<b>marantz®</b> <b>SERVICE BULLETIN</b>		Date: 15-May-2003	Model: SR5200/SR6200/SR7200
		Page: 1/2	REF.NBR: MZ02-033
Circulation:		Subject:	
Application:		Hum noise can be heard from Headphone out.	
x for information customer complaint in case of service mandatory			
		See below

<b>marantz®</b> <b>SERVICE BULLETIN</b>		Date: 15-May-2003	Model: SR5200/SR6200/SR7200
		Page: 1/6	REF.NBR: MZ02-032
Circulation:		Application:	
x for information customer complaint in case of service mandatory		See below	
		Subject:  Pop noise	
		Int.ref:

<b>marantz®</b> <b>SERVICE BULLETIN</b>		Date: 15-May.-2003	Model: SR5200,SR6200,SR7200
		Page: 1 / 1	REF.NBR: MZ02-027
Circulation:		Subject: Video synchronization problem.	
Application:			
x for information customer complaint in case of service mandatory .....		See Below	
		Int.ref:

<b>marantz®</b> <b>SERVICE BULLETIN</b>		Date: 15-May.-2003	Model: SR5200,SR6200,SR7200
		Page: 1 / 1	REF.NBR: MZ02-039
Circulation:		Application:	
x for information customer complaint in case of service mandatory .....		See Below	
		Subject: The damage of the power transistor	
		Int.ref:

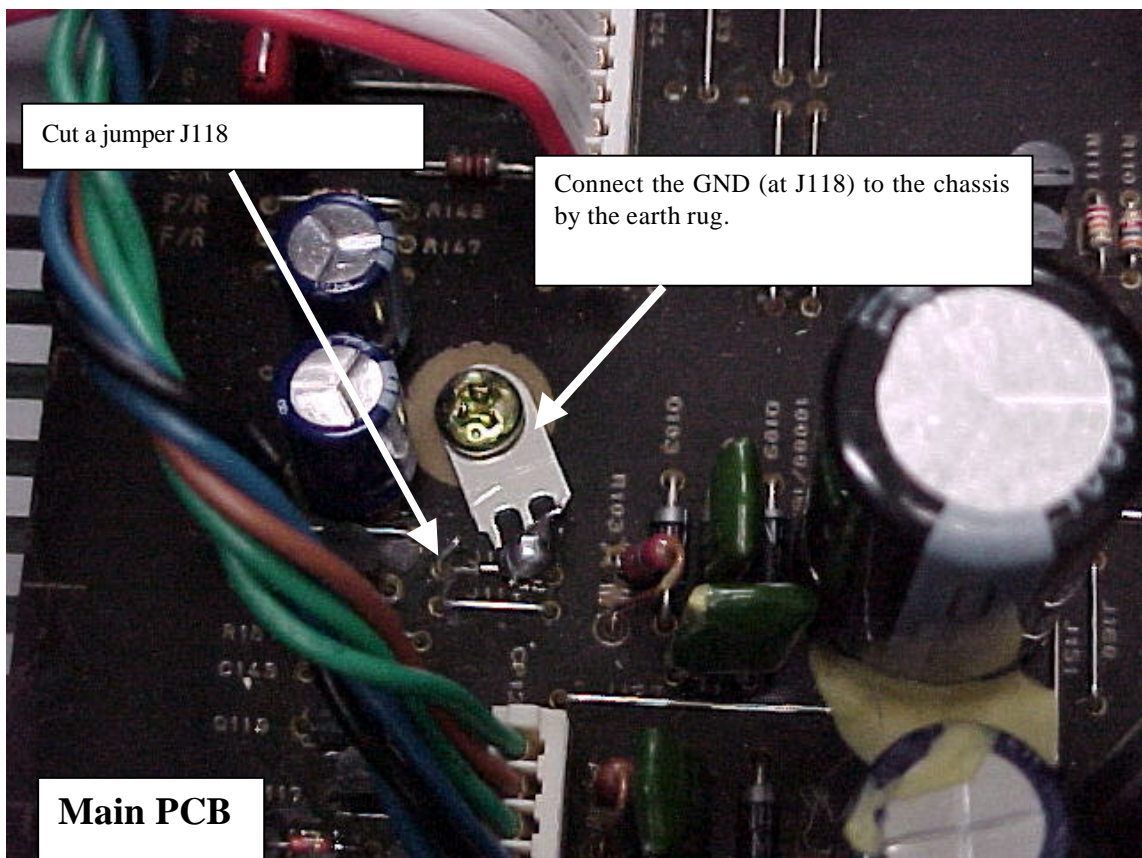
Hum noise can be heard from Headphone out

Caused by ground loop of the headphone out.

Please apply the following solution.

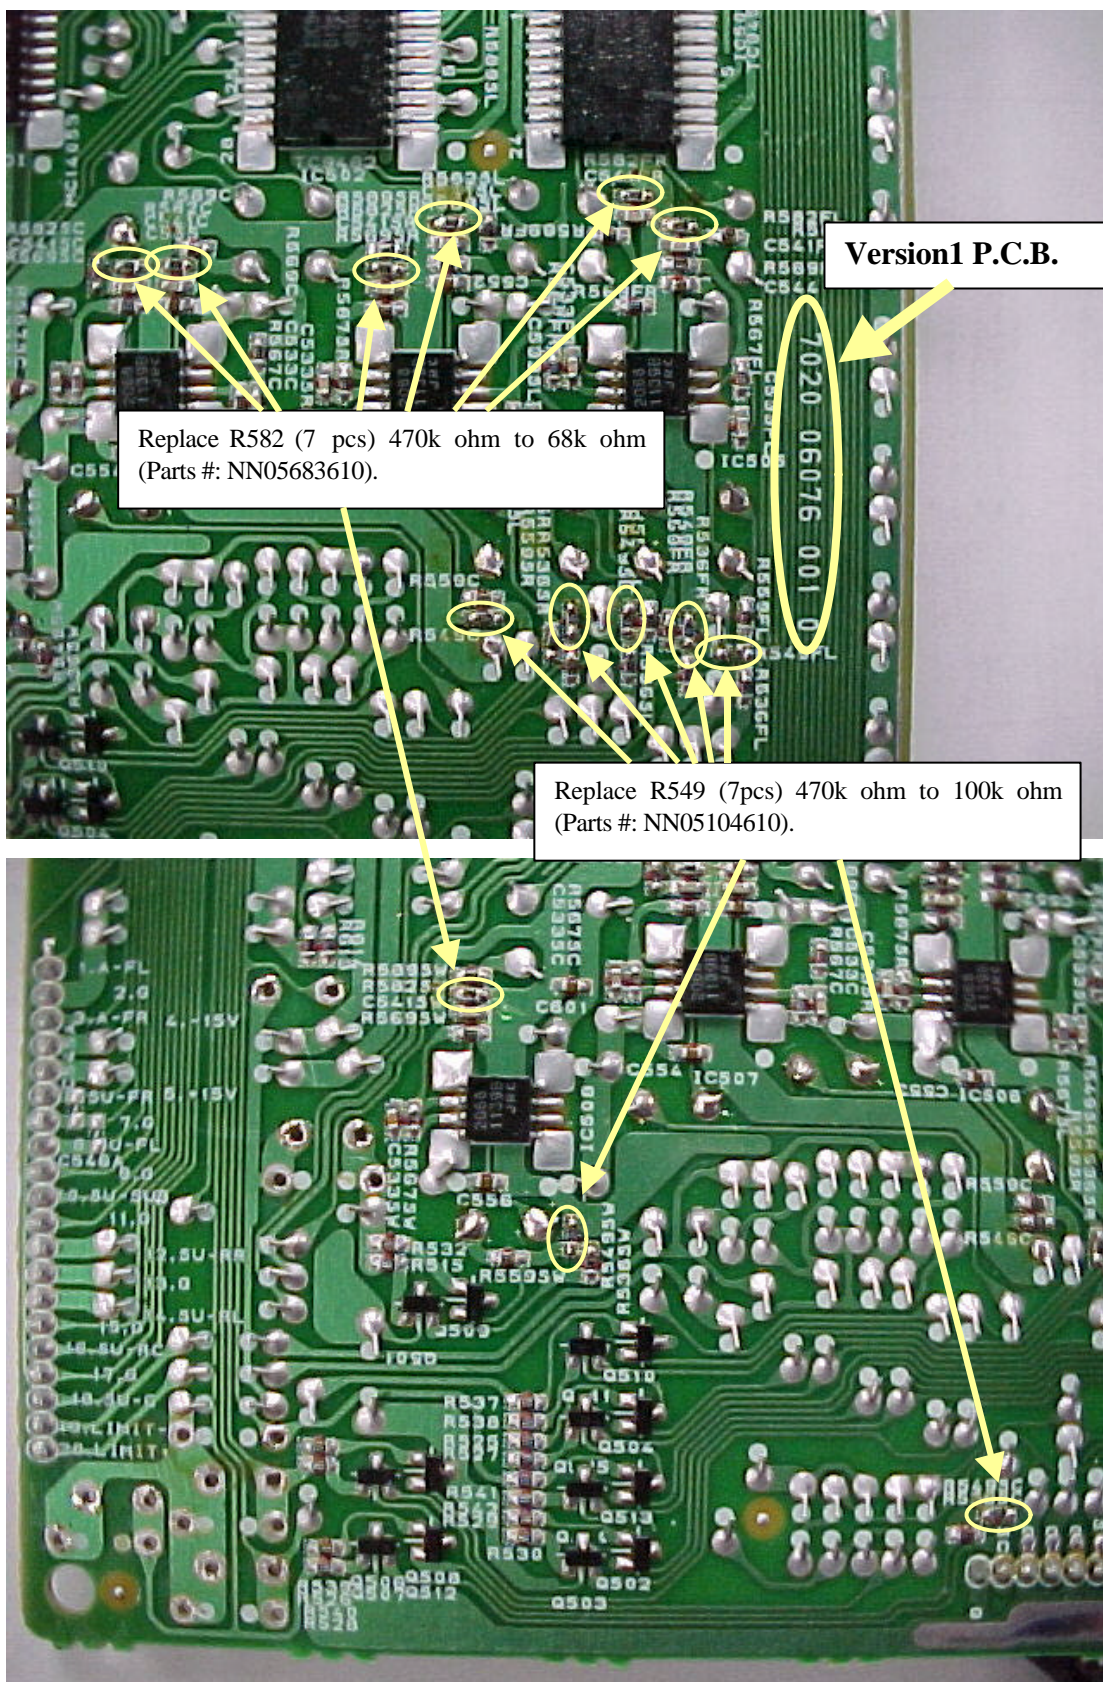
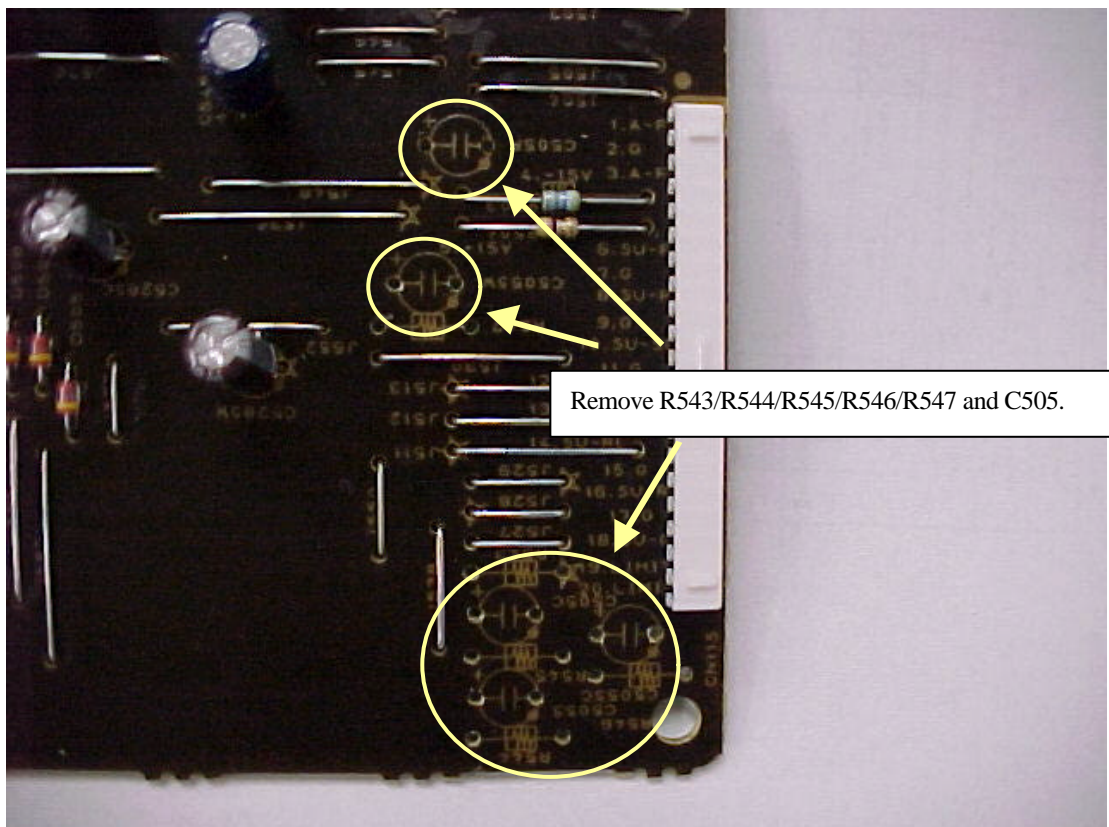
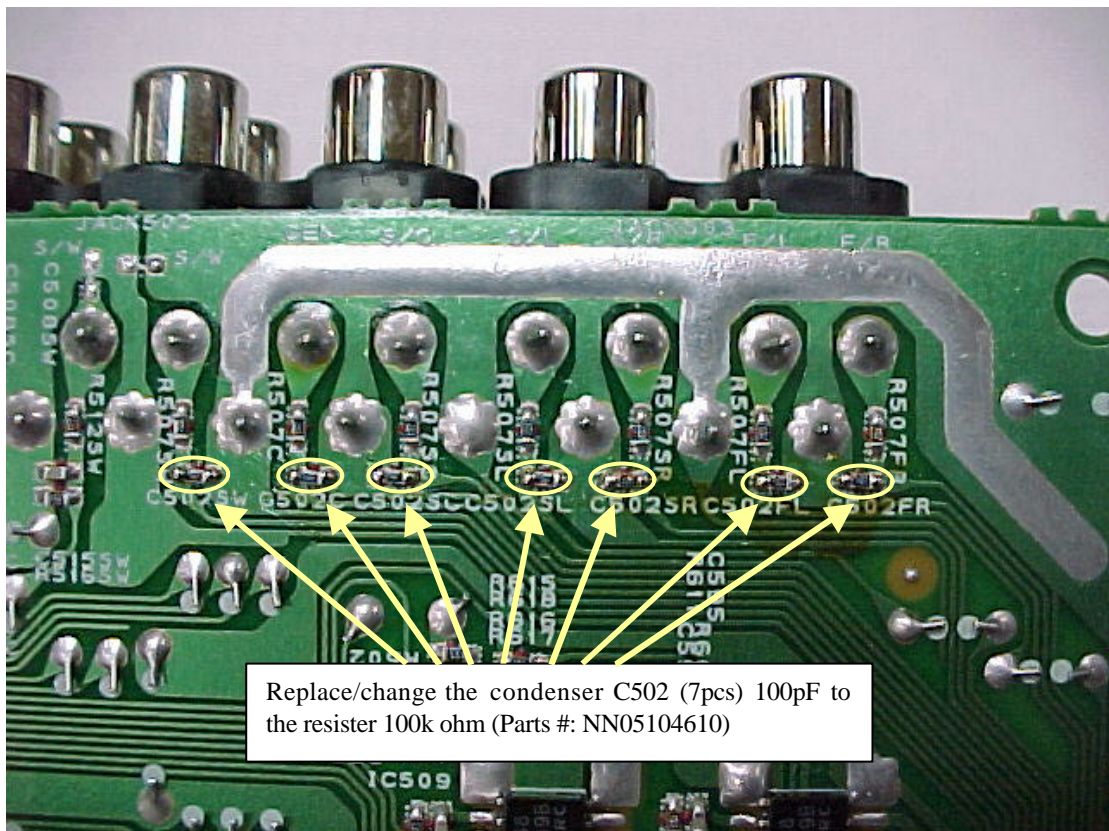
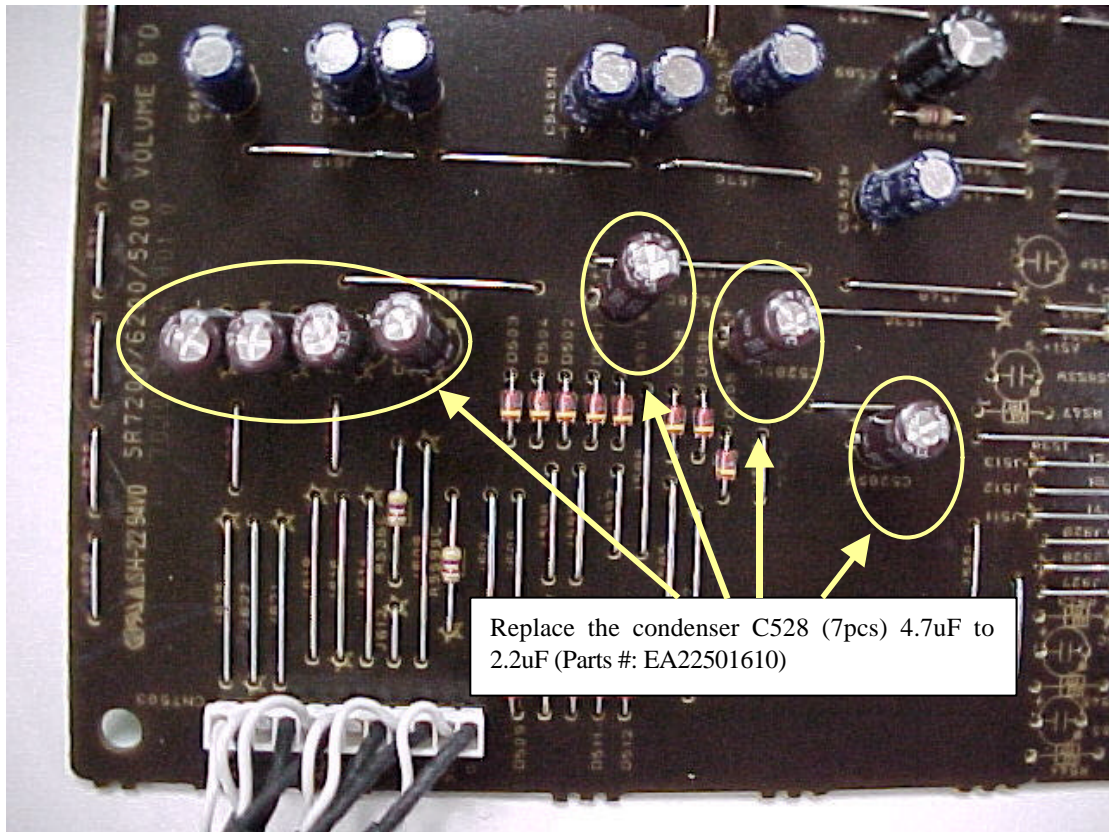
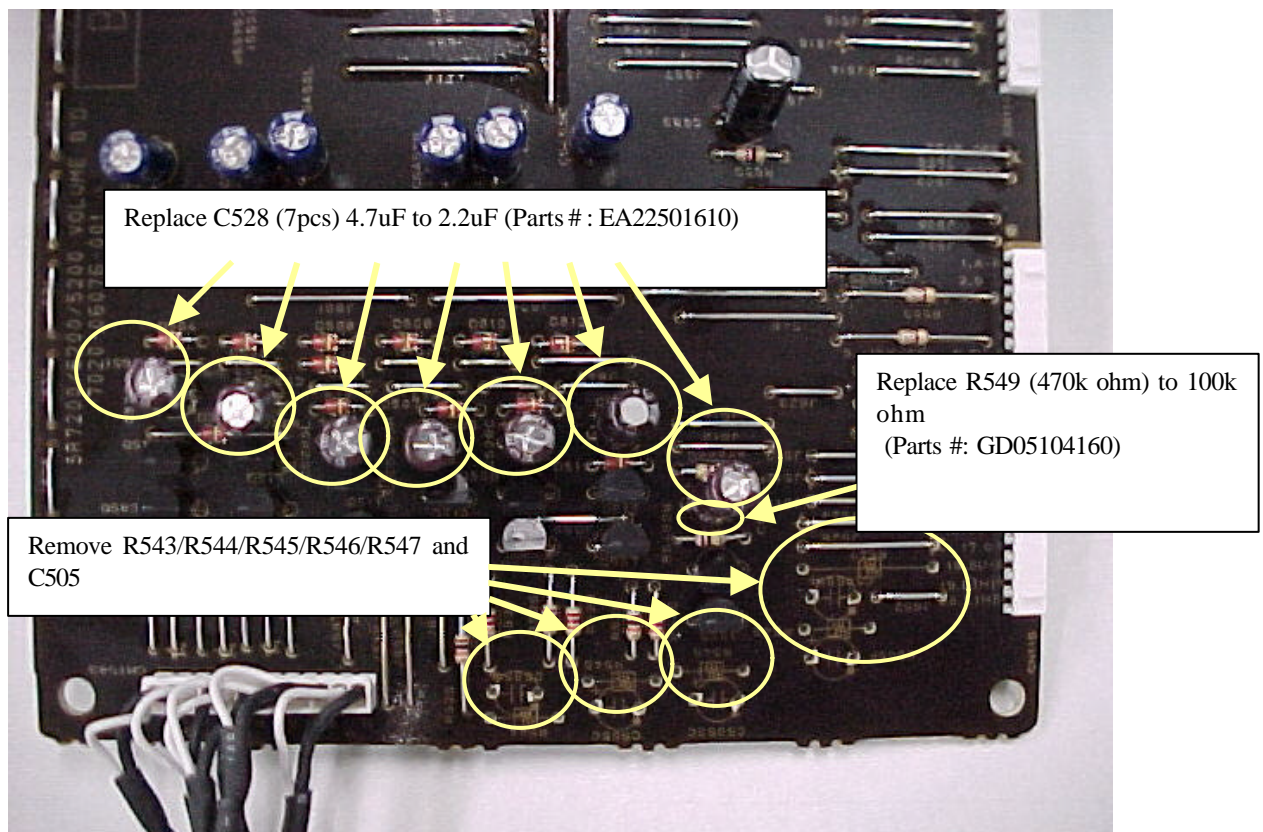
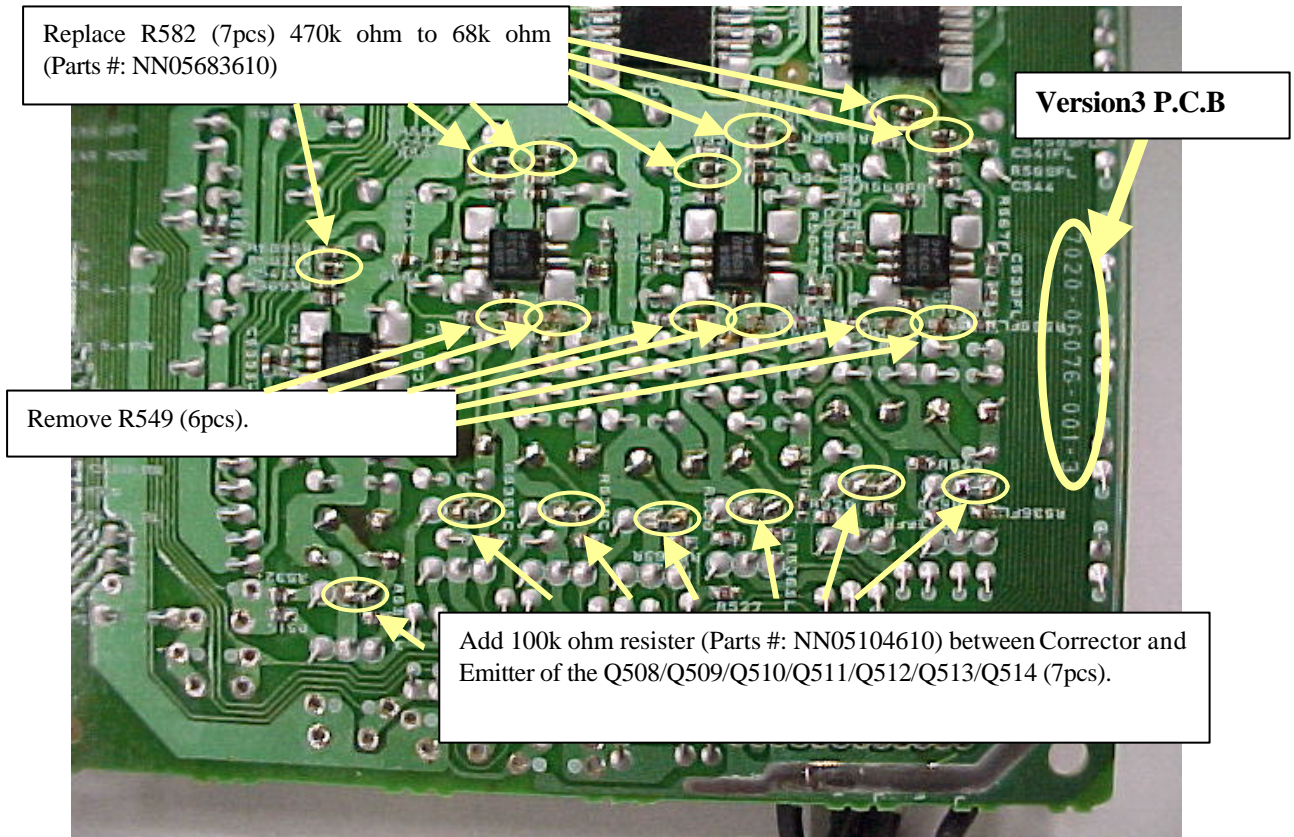
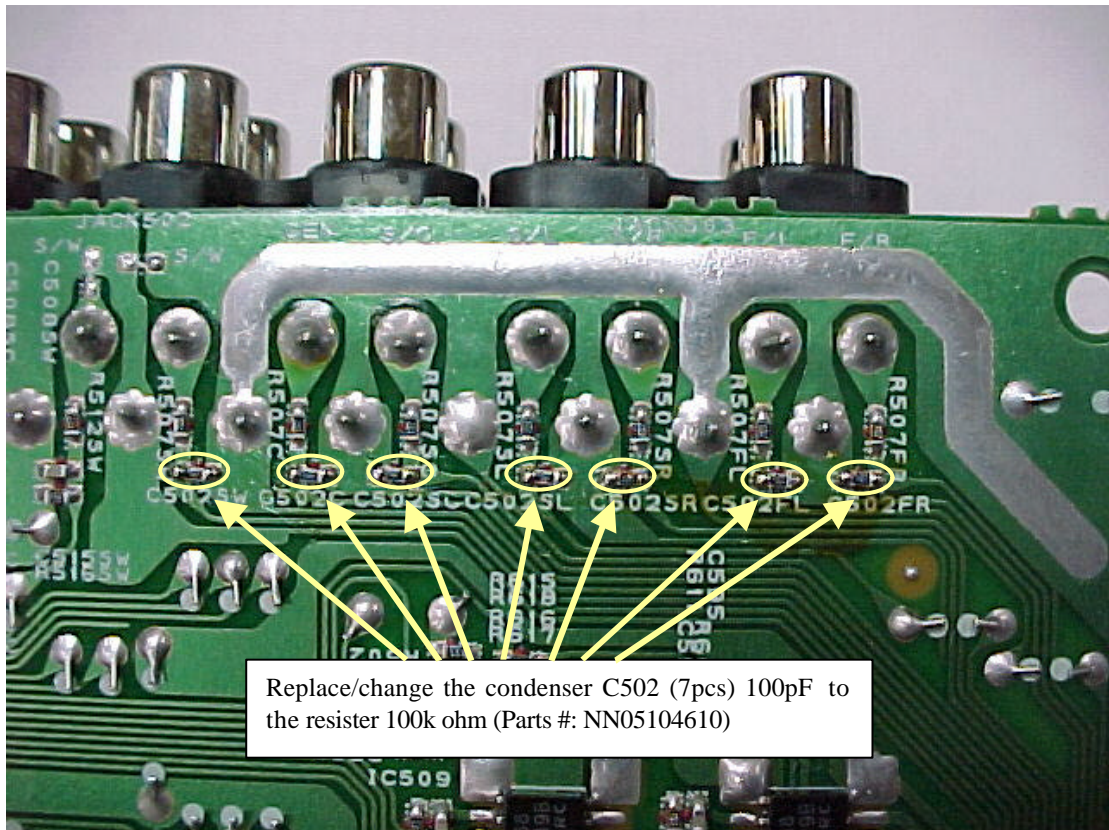
Pop noise appears when stop playing or track skip on CD playback with Digital connection.  
Pop noise appears in the condition of the Main volume is changed 74dB to 75dB(Mute) .

\* Version 1 P.C.Board (7020 06076 001-0) : Please apply the modification mentioned on Page2 to 4.

\* Version 2 P.C.Board (7020 06076 001-3) : Please apply the modification mentioned on Page5 to 6.

\* Version 1 P.C.Board (7020 06076 001-0) : Please apply the modification mentioned below (Page2 to 4).

\* **Version 3 P.C.Board (7020 06076 001-3)** : Please apply the modification mentioned below (Page 5 to 6).

Replace/change the condenser C502 (7pcs) 100pF to the resistor 100k ohm (Parts #: NN05104610)

PIC.01

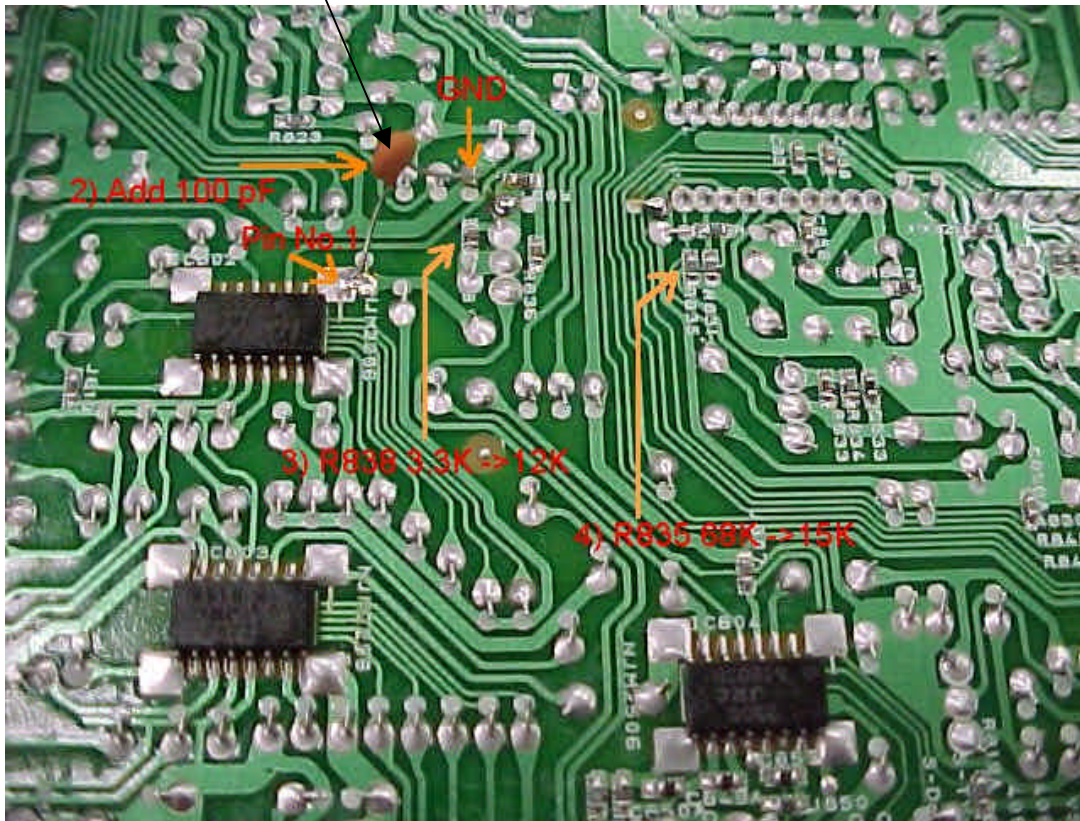
- 1) The capacitor(C810A 100pF: DK16101300 4822 122 33195) is added between 1P of IC802 and GND(refer to PIC.01).
- 2) The jumper wire(J841) is deleted and a capacitor(C840A 47uF/16V: EA47601620 9965 000 06289) is added to same position (refer to PIC.02).
- 3) The chip resistor(R838) is changed into 12kohm one(NN05123610 4822 051 30123) from the present 3.3kohm one.
- 4) The chip resistor(R835) is changed into 15kohm one(NN05153610 4822 051 30153) from the present 68kohm one.

C810A (100pF: DK16101300

4822 122 33195)

PIC.02

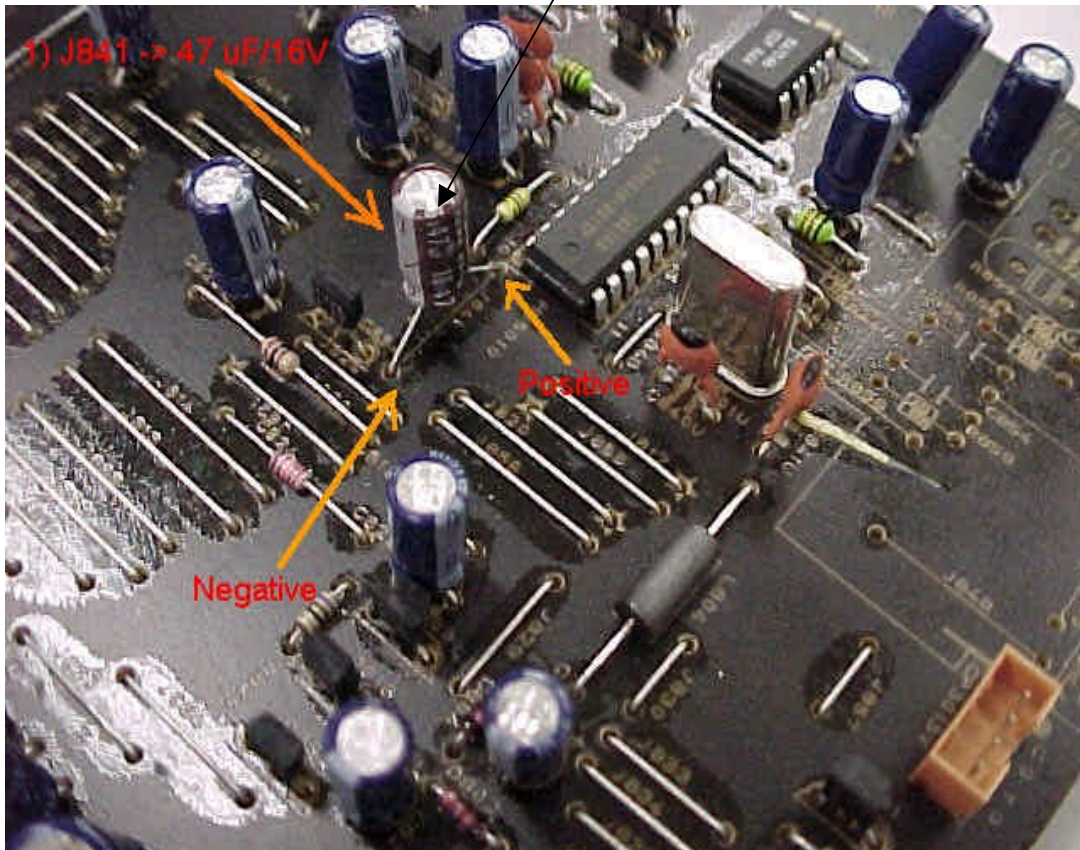
C840A (47uF/16V:EA47601620

9965 000 06289)
